Informal Document No. **GRE-61-03**
(61st GRE, 30 March - 3 April 2009
agenda item 3(b))

**Proposal for draft Corrigendum 1 to Supplement 33 to the 03 series of amendments to
Regulation No. 37 (Filament lamps)
(ECE/TRANS/WP.29/2009/18)**

The new sheets H10W/1 to 2, between sheet H6W/1 and sheet H21W/1, amend to read (see next pages):

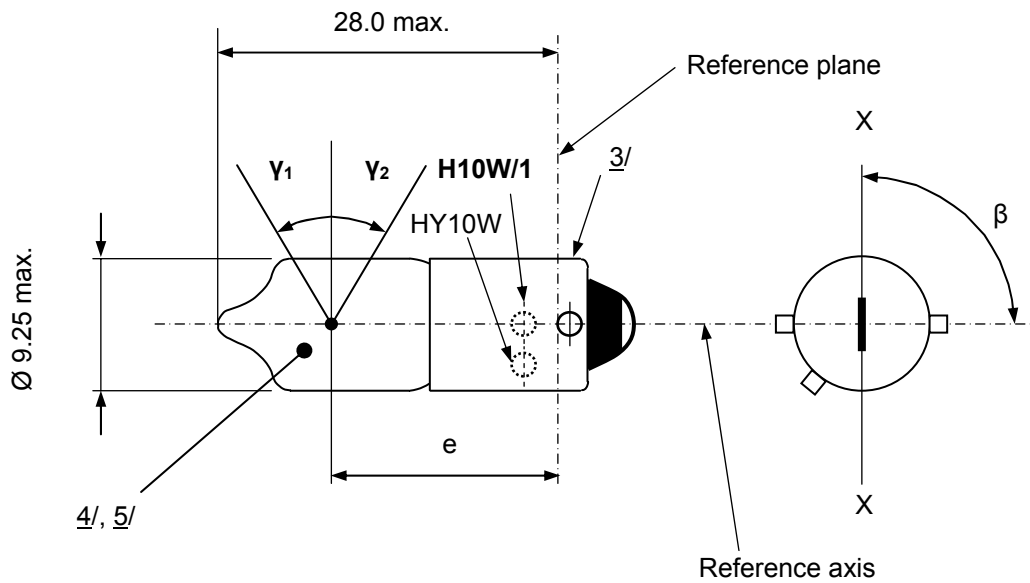
The proposal for Supplement 33 to the 03 series of amendments to Regulation No. 37, was adopted by GRE at its last October 2008 session. However, it has been investigated that the category H10W already exists in IEC60983 standard but with different technical specifications. Accordingly, H10W category should be replaced by H10W/1 throughout the text.

Dimensions in mm		Filament lamps of normal production			Standard filament lamp
		min.	nom.	max.	
e		14.25	15.0	15.75	15.0 ± 0.25
Lateral deviation	<u>1/</u>			0.75	0.4 max
β		82.5°	90°	97.5°	90° ± 5°
γ1, γ2	<u>2/</u>	30°			30° min.
Cap:	H10W/1: HY10W	BAU9s BAUZ9s	in accordance with IEC Publication 60061 (sheet 7004- [...]) in accordance with IEC Publication 60061 (sheet 7004- [...])		
ELECTRICAL AND PHOTOMETRIC CHARACTERISTICS					
Rated values	Volts	12			12
	Watts	10			10
Test voltage	Volts	13.5			13.5
Objective values	Watts	12 max.			12 max.
	Luminous flux	H10W/1	200 ± 12 %		
		HY10W	120 ± 17 %		
Reference luminous flux at approximately 13.5 V					White: 200 lm Amber: 120 lm

- 1/ Maximum lateral deviation of filament centre from two mutually perpendicular planes both containing the reference axis and one containing axis X-X.
- 2/ In the area between the outer legs of the angles γ_1 and γ_2 , the bulb shall have no optically distorting areas and the curvature of the bulb shall have a radius not less than 50 % of the actual bulb diameter.
- 3/ Over the entire length of the cap there shall be no projections or soldering exceeding the permissible maximum diameter of the cap.
- 4/ The light emitted from filament lamps of normal production shall be white for category **H10W/1** and amber for category HY10W.
- 5/ The light emitted from standard filament lamps shall be white for category **H10W/1** and amber or white for category HY10W. "
